Munson Township
Croatian Lodge Dam Removal and Stream Restoration Project
Responses to Contractor Inquiries

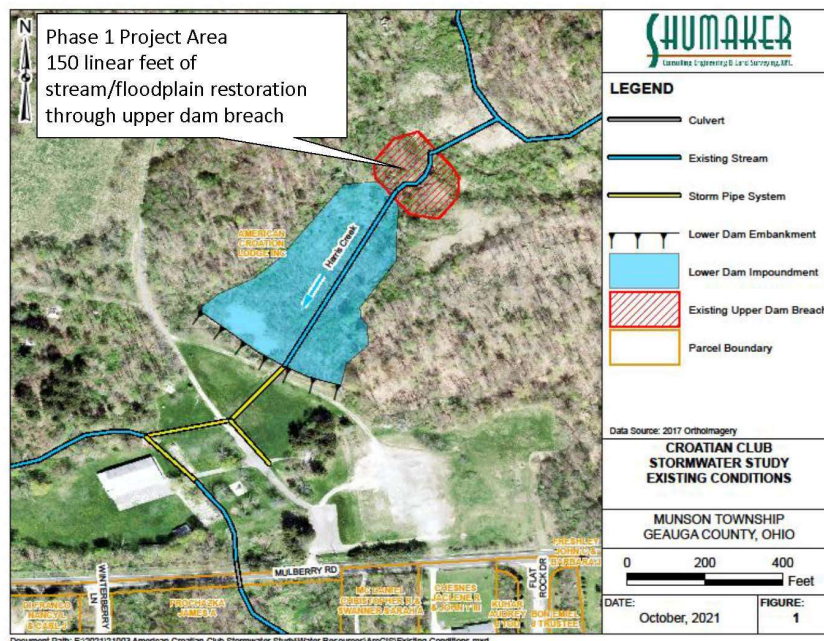
4. Where are the three acres of IVC intended?

The three acres of IVC treatment should be focused within the upper dam project area outlined in the red hatched area below. Additional IVC treatment may be included as part of future project phases or as needed for construction access.

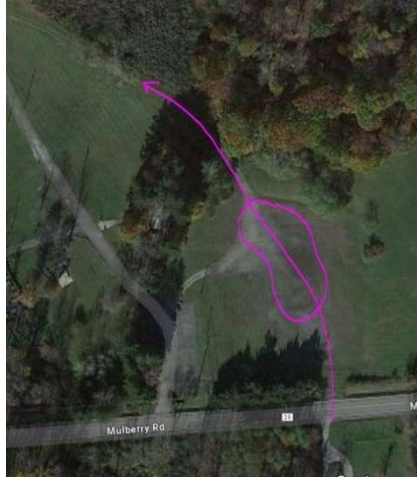
6. How would the site be accessed? Can the secondary driveway be used for construction access and staging as illustrated below?

The project site is most accessible from the east from a flatter area. Some brush clearing would be necessary to access the site from this location. The site mapped above can be used for temporary access and staging during construction.
